MANASQUAN PLANNING BOARD MEETING AGENDA

Re: Boro File No. MSPB-R2200 Variance – Nelson Block 122, Lot 25 321 Cedar Avenue R-2 Single-Family Residential Zone Borough of Manasquan, Monmouth County, NJ

Re: Boro File No. MSPB-R2210
Variance – Mark D. Hall Family Trust
Block 177, Lot 33.03
155 First Avenue
R-5 Single-Family Residential Zone
Borough of Manasquan, Monmouth County, NJ

Re: Boro File No. MSPB-R2230 Variance – Young/Estate of Emily Zirkler Block 168, Lot 16 139 First Avenue R-5 Single-Family Residential Zone Borough of Manasquan, Monmouth County, NJ

PROPOSED ADDITION & RENOVATION: 321 CEDAR AVE.

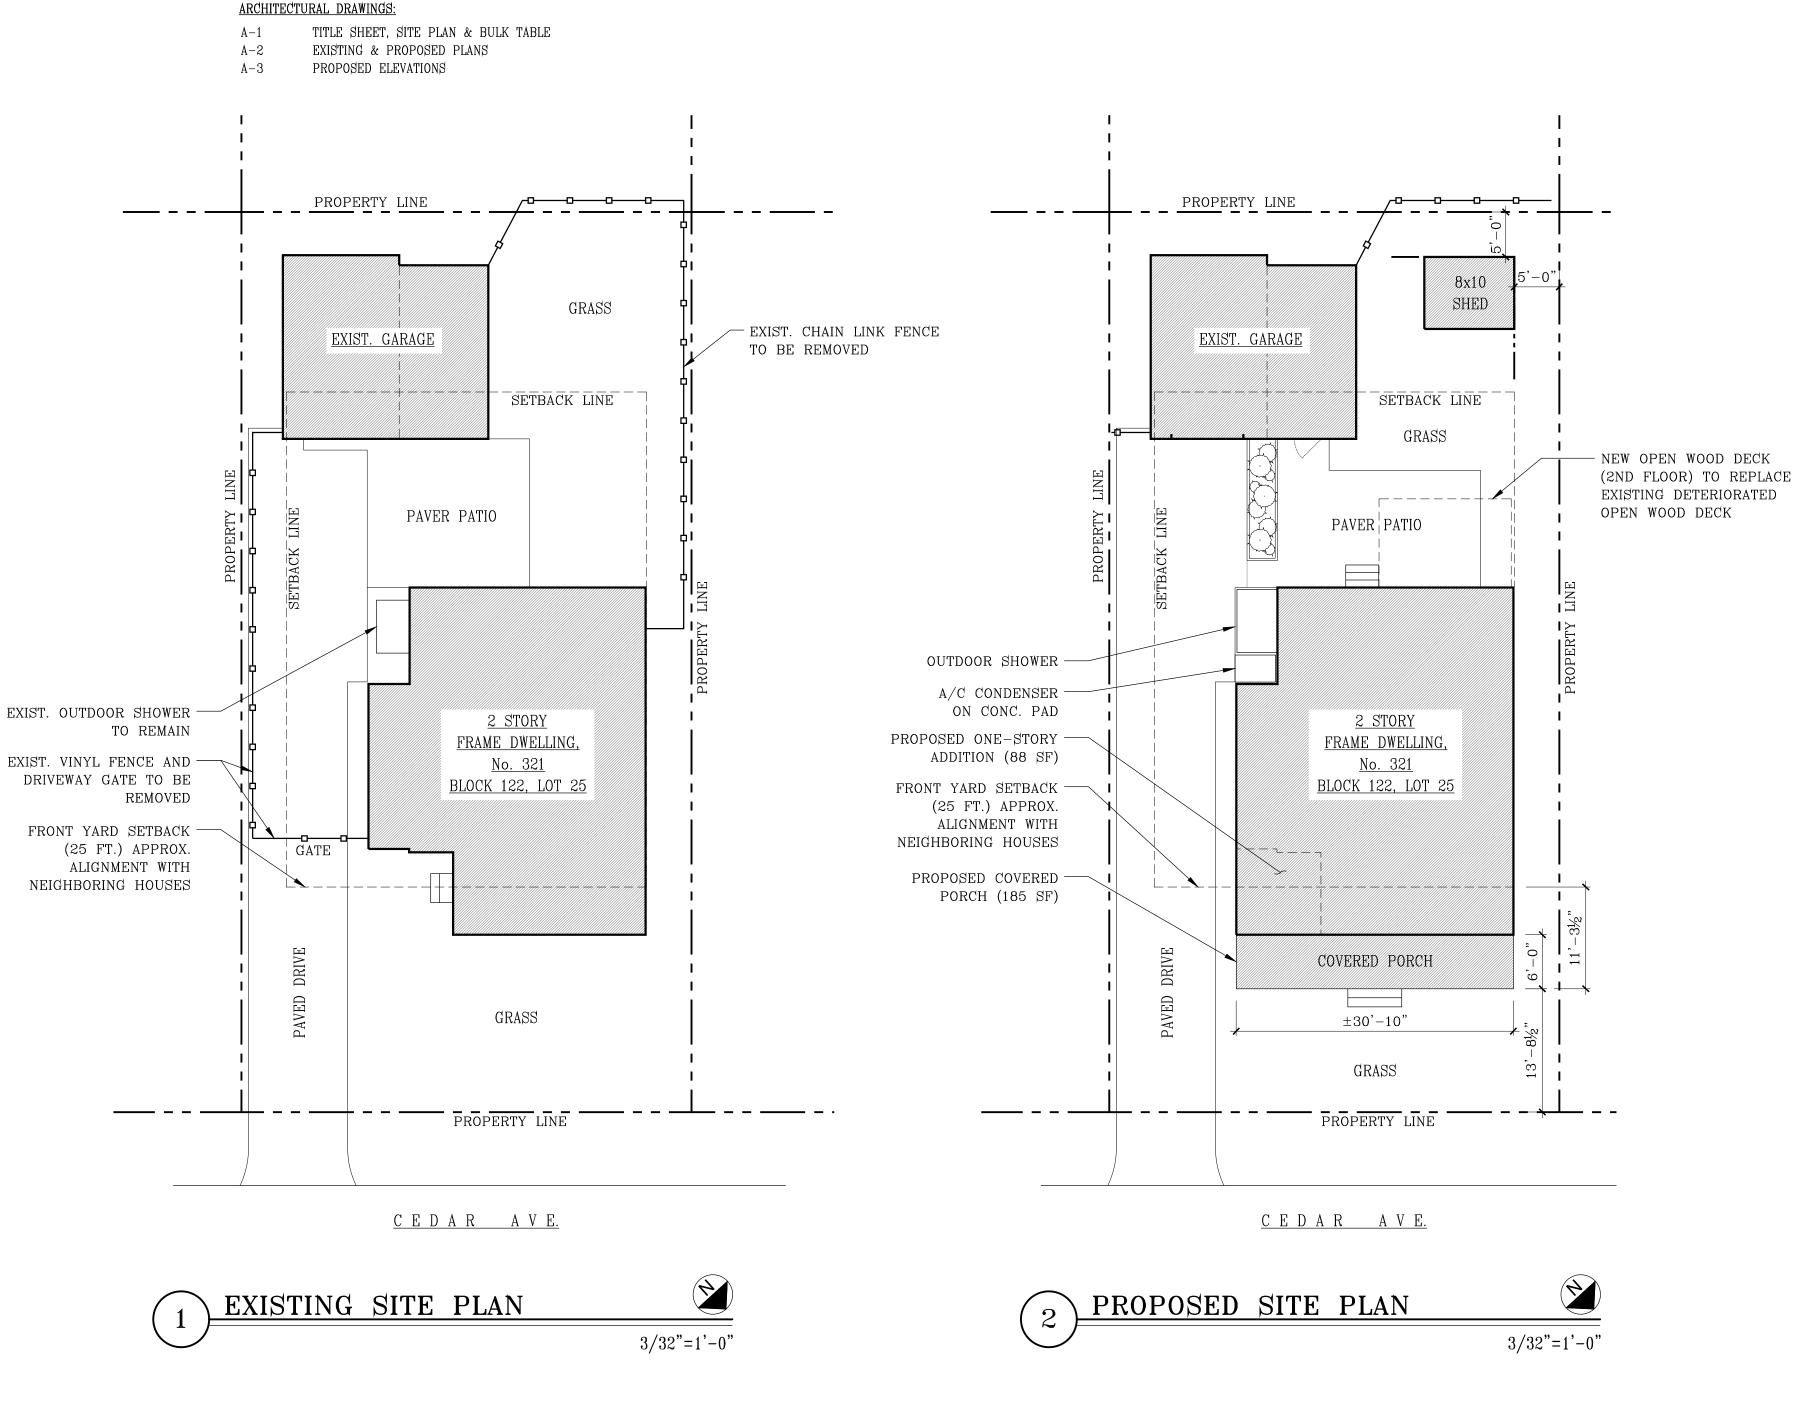
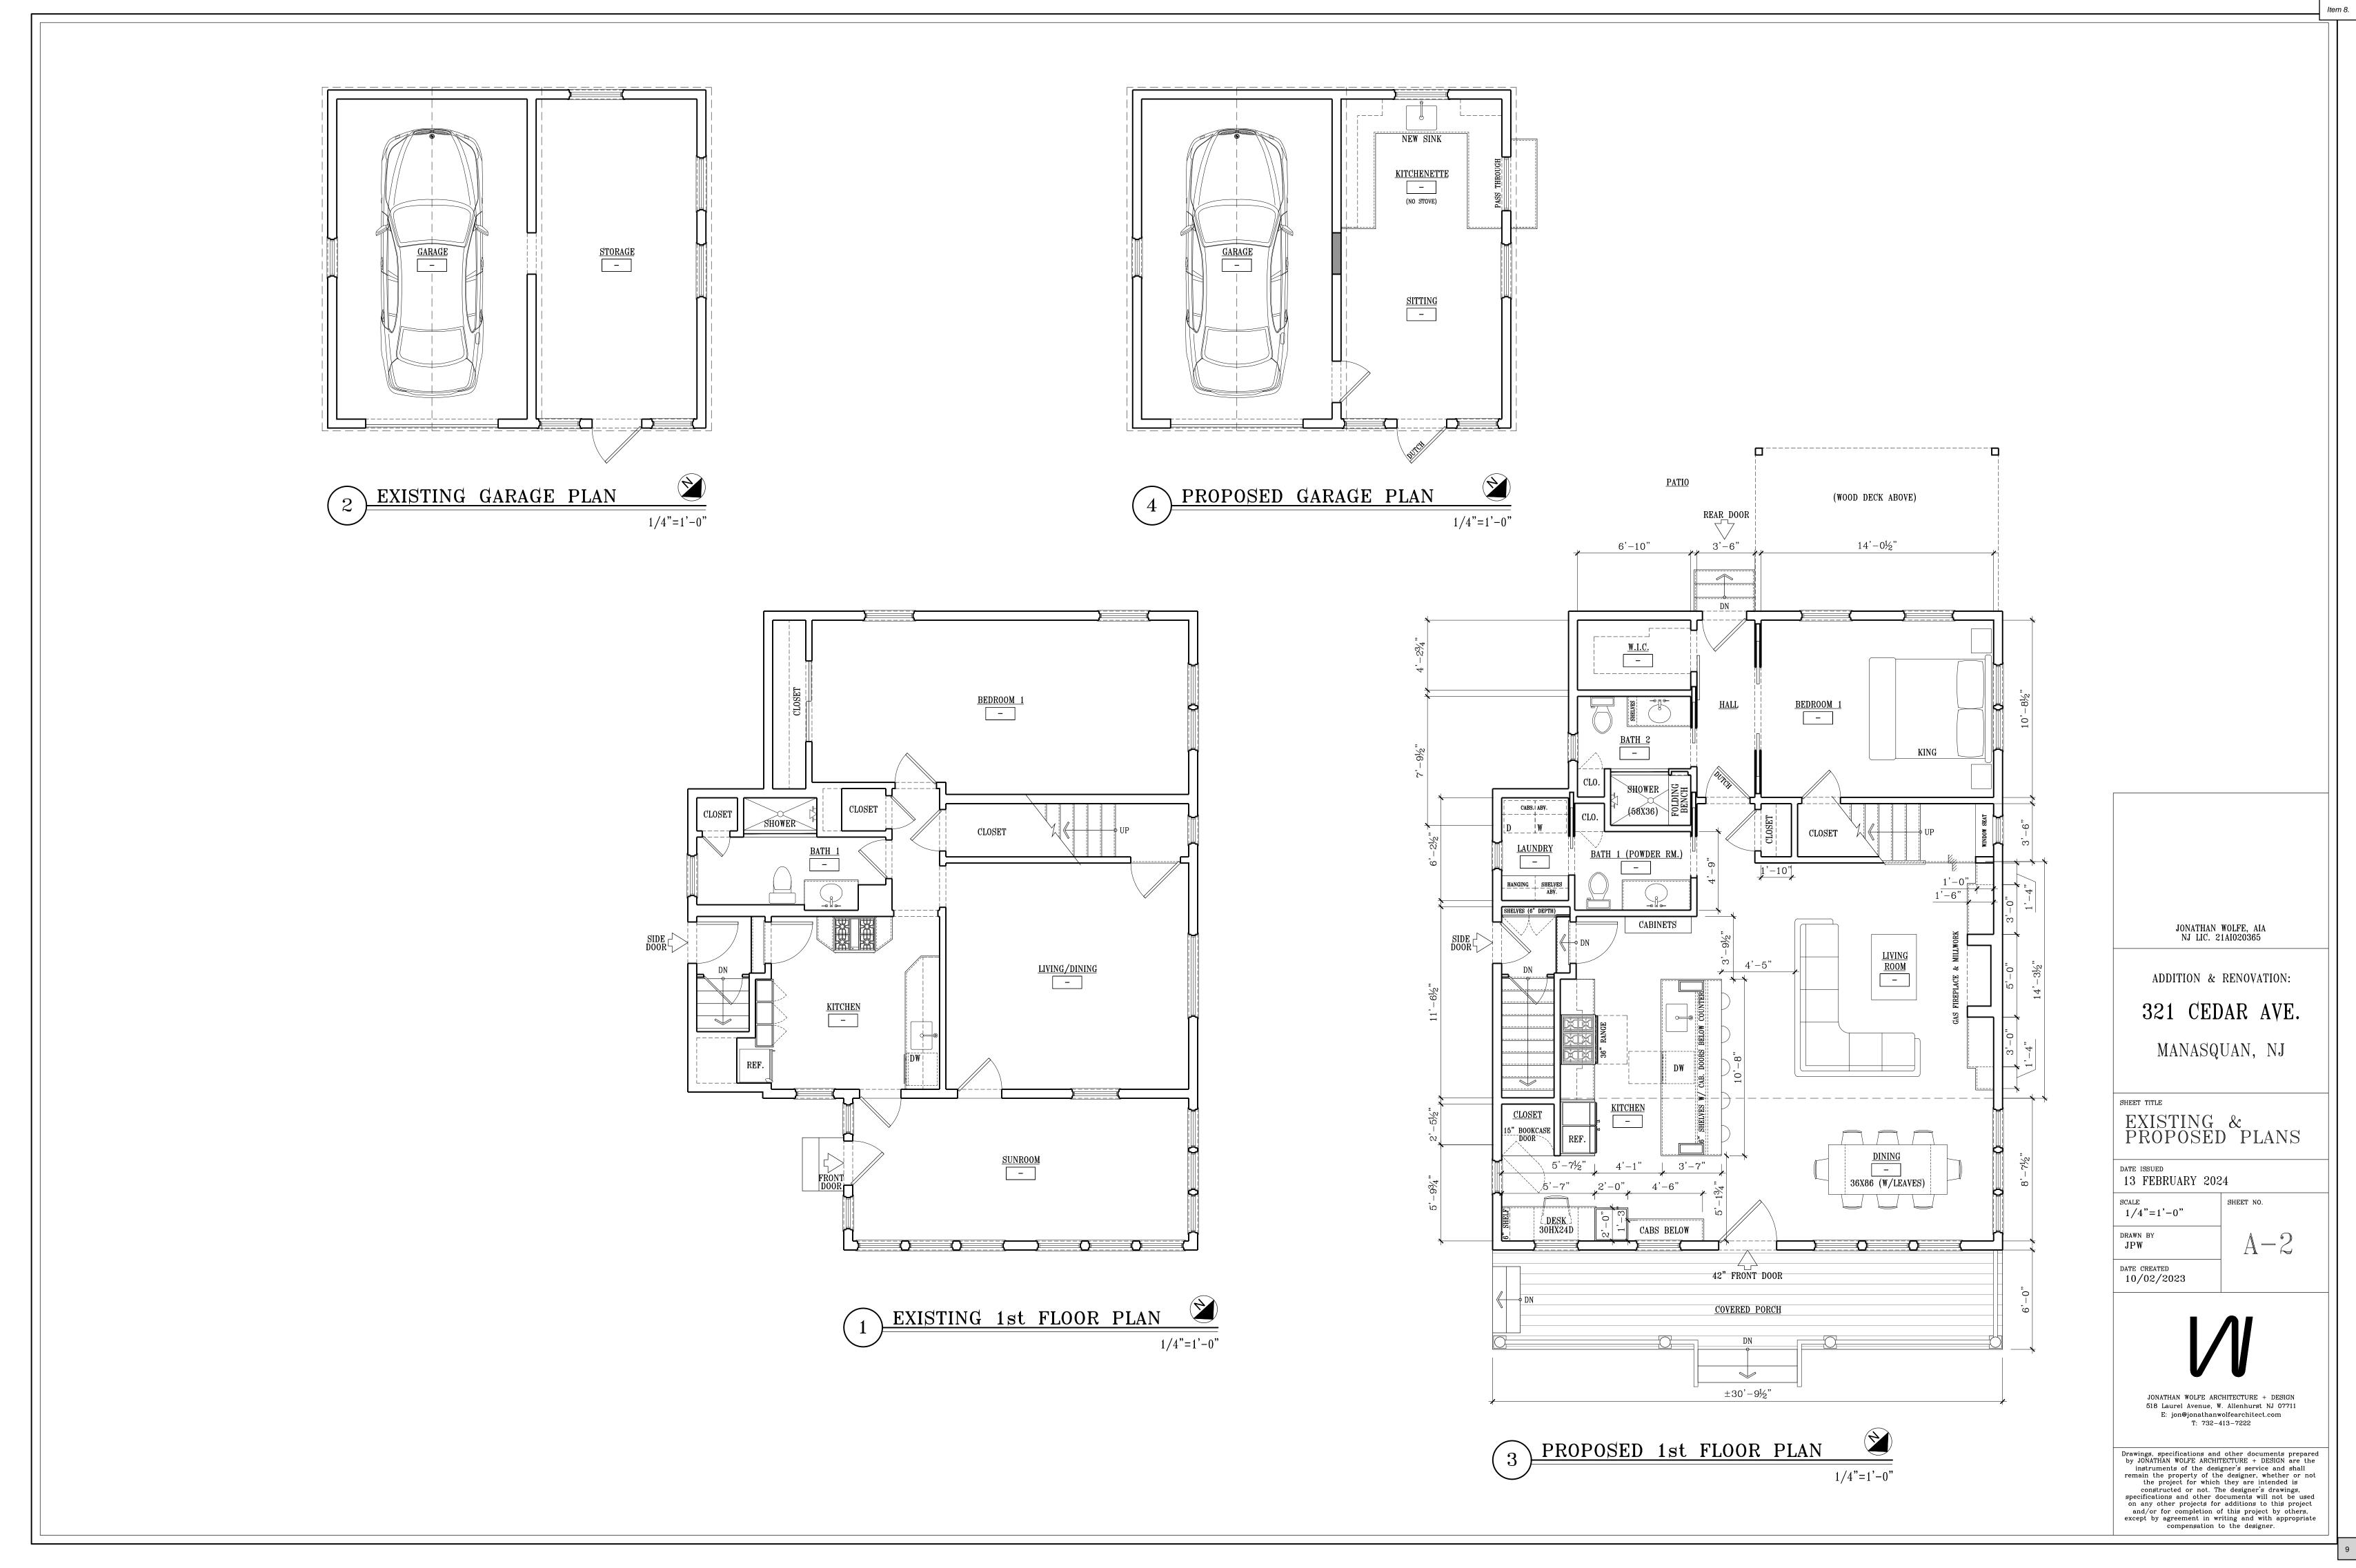
- b. A minimum accessory rear yard setback of 5 feet is required, whereas a setback of 4.6 feet exists to the detached garage.
- 4. The plan should be revised to show any proposed landing and housewalk from the new front steps to the driveway or street. The material of this walkway must be indicated as there will be an increase in lot coverage if an impervious material is proposed. This may also affect the requested variance. The plan should be revised, and the exact lot coverage variance request must be provided.

- 5. The base flood elevation for the property is 9 (Zone AE). The existing and proposed finish first floor of the dwelling has not been provided but is not proposed to be modified. The actual finish floor elevation should be provided on the plan.

- 6. The location of the air conditioning unit is to be outside of the easterly side yard setback and behind the building envelope on a raised platform.

EXISTING CONDITIONS PLAN PREPARED FOR LOT 33.03, BLOCK 171 SITUATED IN THE **BOROUGH OF MANASQUAN** MONMOUTH COUNTY, NEW JERSEY

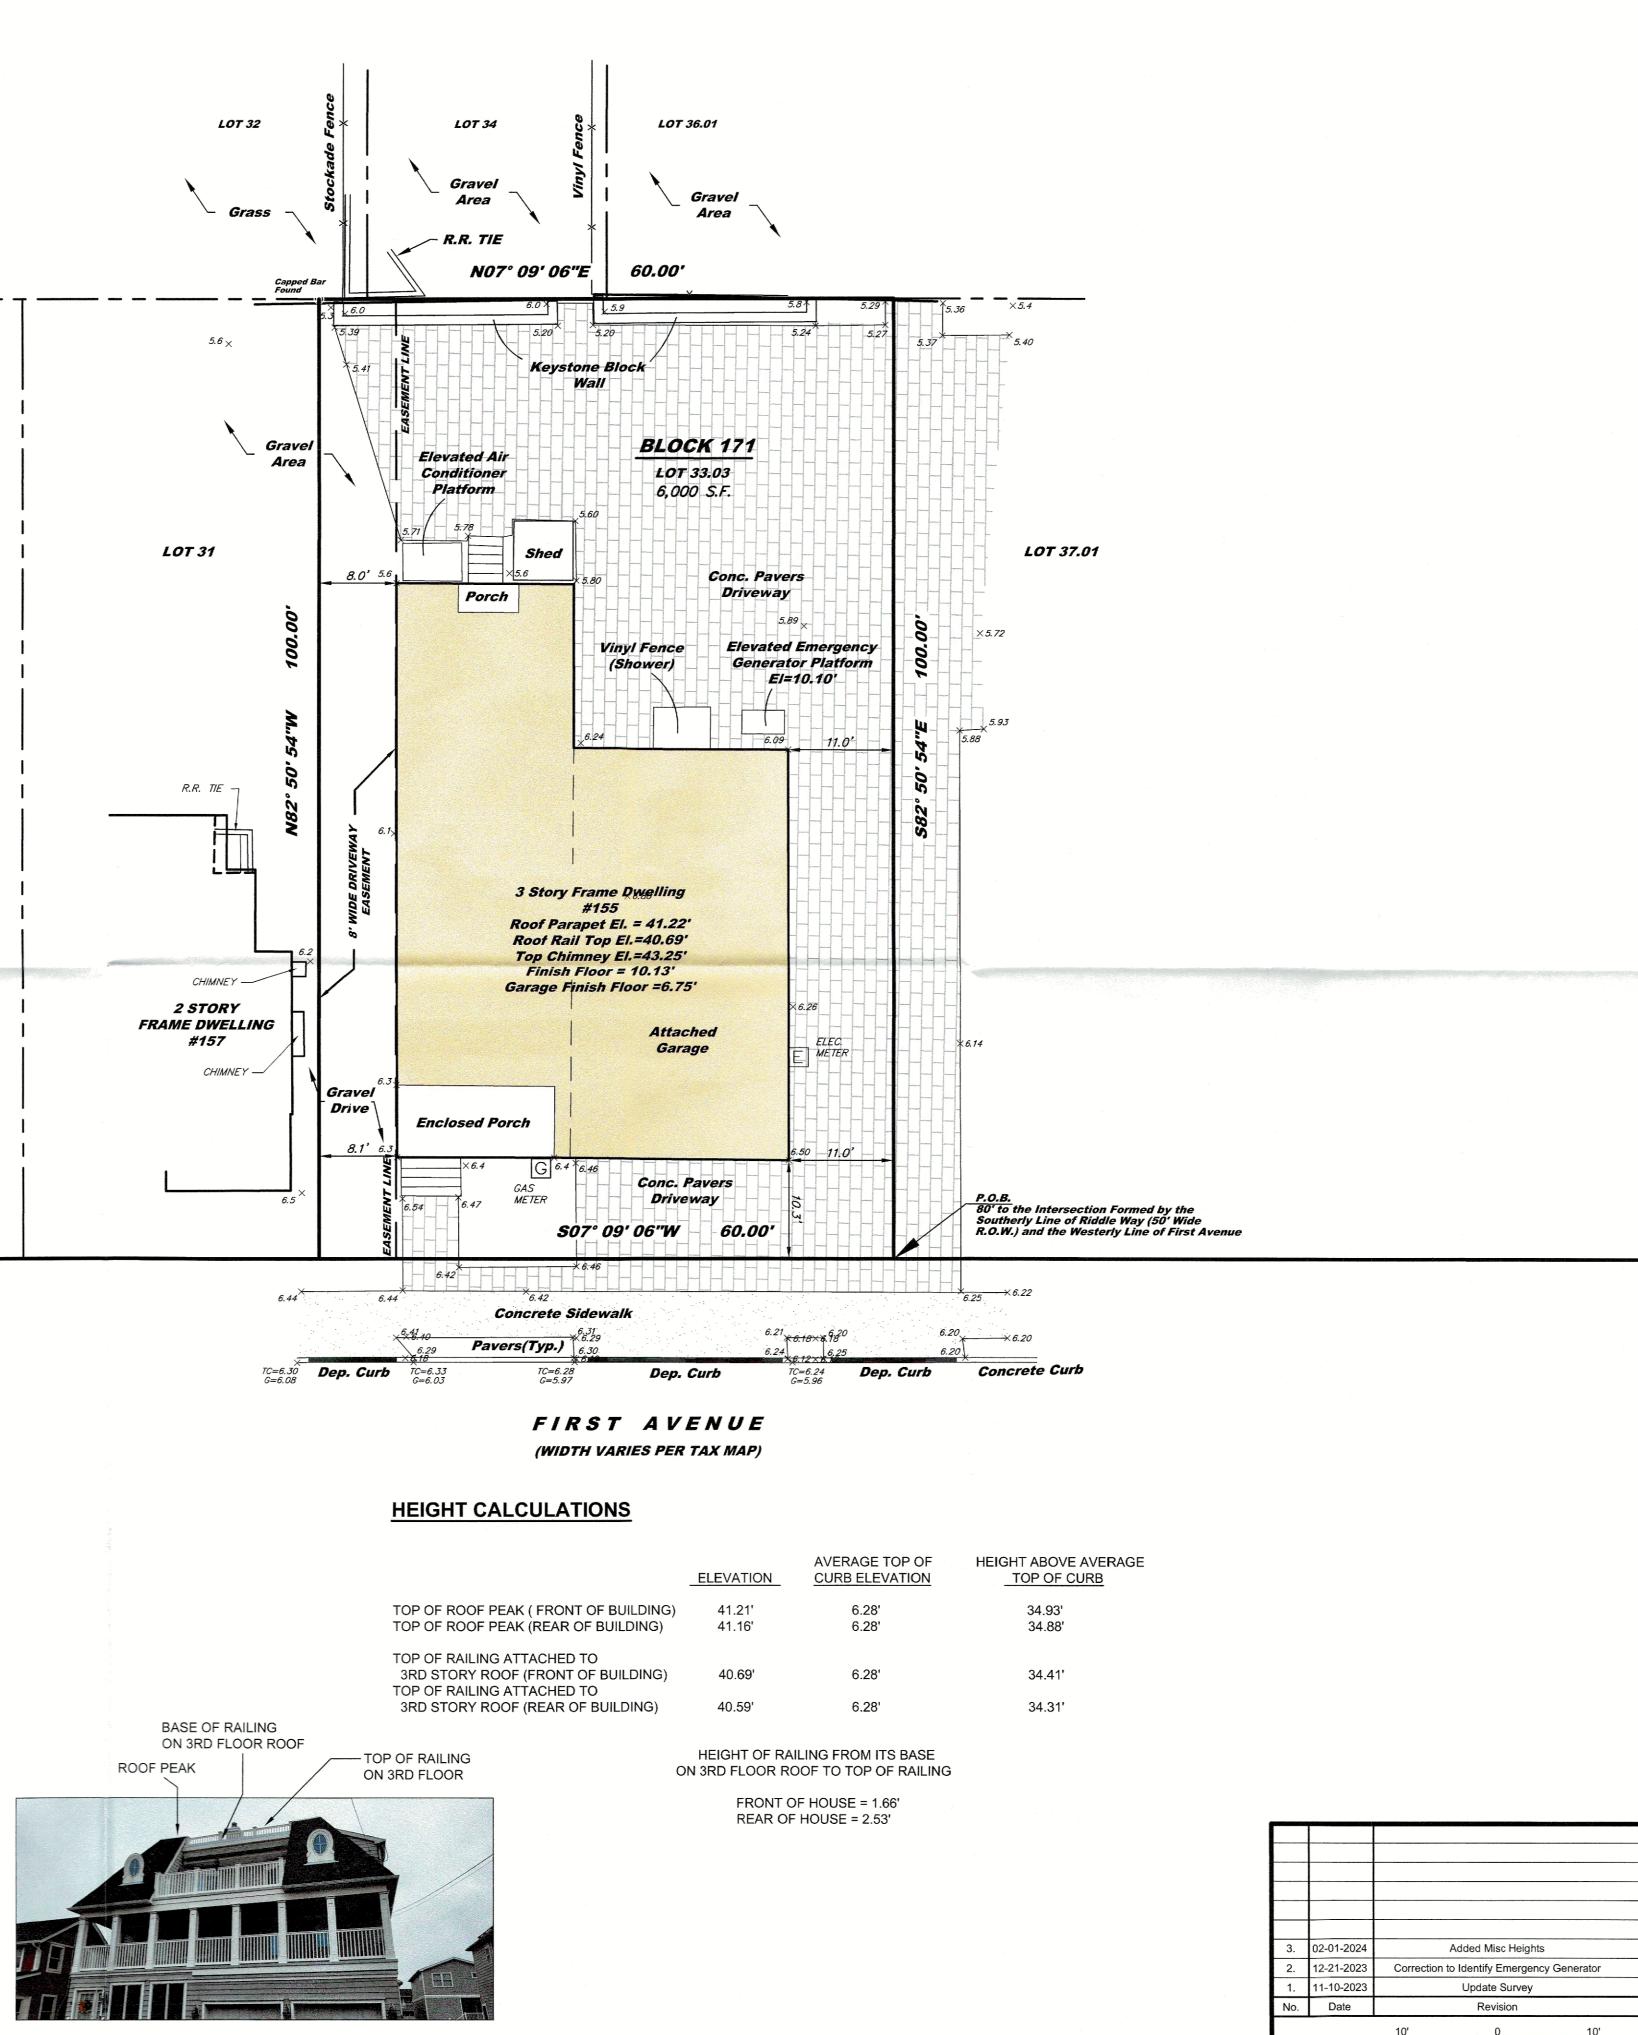
- 5. The proposed railing around the deck will increase the total building height by 1 foot to 35.92 feet. This railing would be required to provide a 3 feet high railing around the roof deck in accordance with applicable building codes.
